**From:** Lasley, Timothy G  
**Sent:** Thursday, June 21, 2018 3:58 PM  
**To:** 'carlae@purplecherry.com'  
**Cc:** Werner, Jeffrey B; Mess, Camie  
**Subject:** BAR Action - June 19, 2018 - 404 East Main Street

BAR 18-06-01

404 East Main Street

Window replacement

**EXHIBIT C - REAR ELEVATION@ 1ST FLOOR**

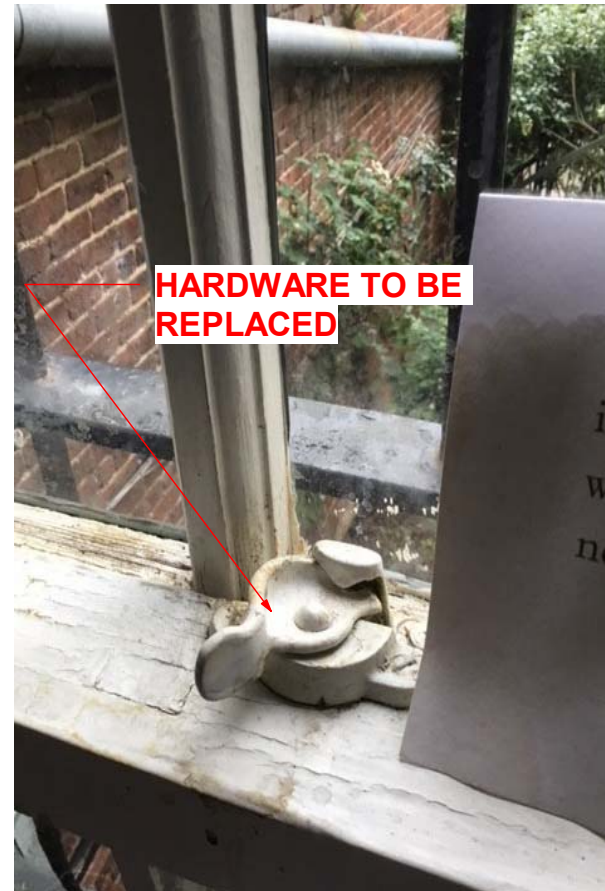
**HISTORIC WINDOW TO BE REPLACED**

**GRILLES ON WINDOWS TO BE REMOVED**

**WARPED SASH**

**ROT @ SILL**

**HARDWARE TO BE REPLACED**

FIRST FLOOR WINDOWS ON ALLEY SIDE: TWO EXISTING DOUBLE-HUNG UNITS ARE IN VERY POOR CONDITION. ALL UNITS HAVE PERVASIVE WOOD ROT AND EVIDENCE OF WATER INFILTRATION, AND THE SASHES ARE DEFORMED DUE TO WATER DAMAGE. WE ARE PROPOSING TO REPLACE BOTH OF THESE WINDOWS WITH NEW MARVIN ALUMINUM-CLAD DOUBLE-PANE DOUBLE-HUNG UNITS. NEW UNITS ARE TO HAVE LOW-E GLAZING AND TRUE DIVIDED LITE CONSTRUCTION WITH 1 1/8" WIDE MUNTINS AND BRONZE CLAD FINISH.

EXISTING HISTORICAL FRONT SASH TO BE REPLICATED

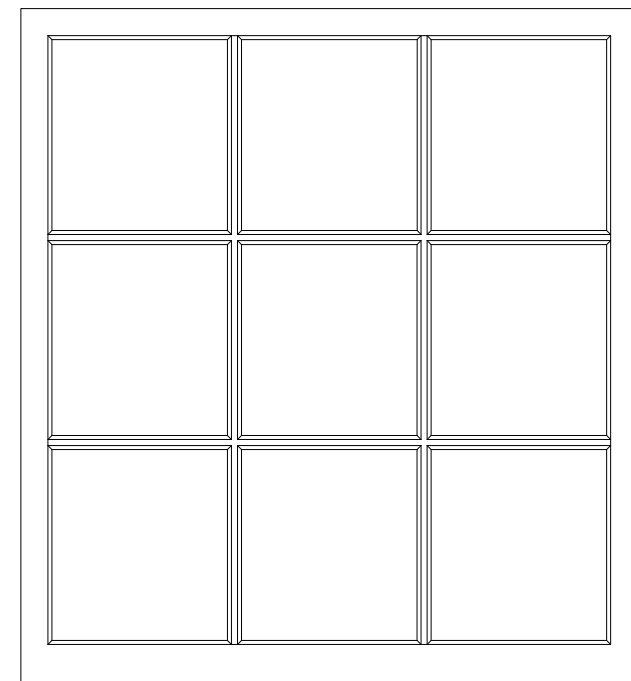
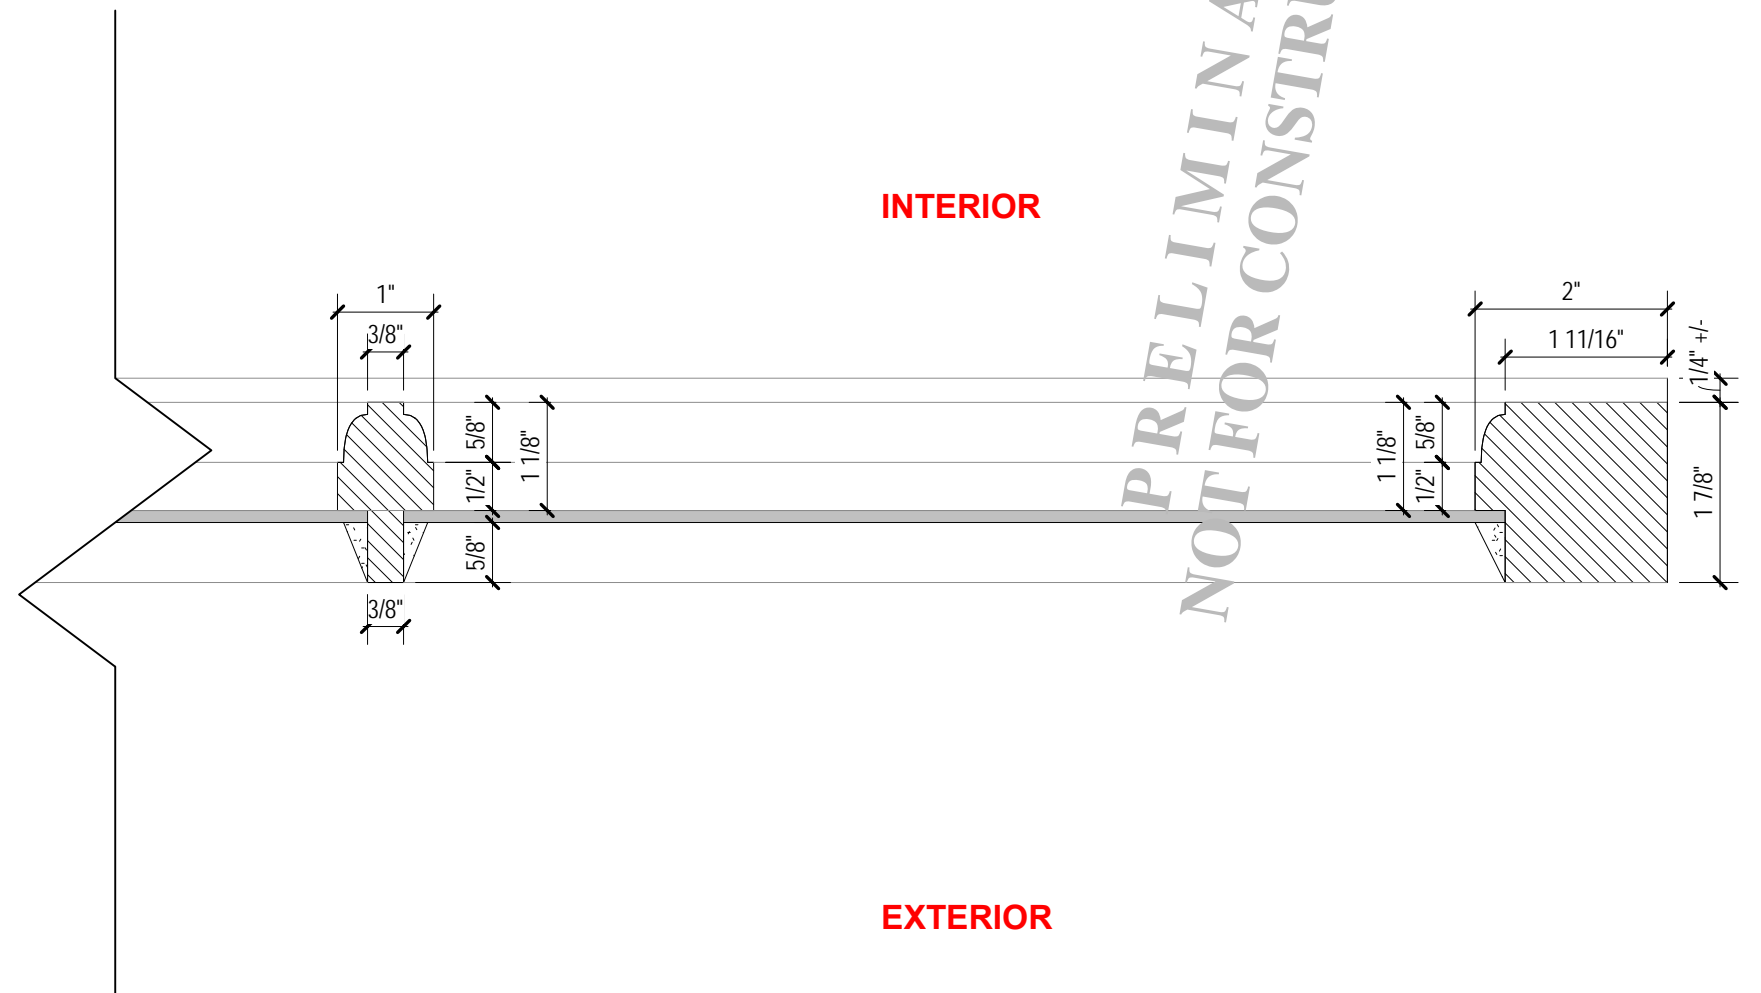
EXISTING HISTORICAL SASH PROFILES
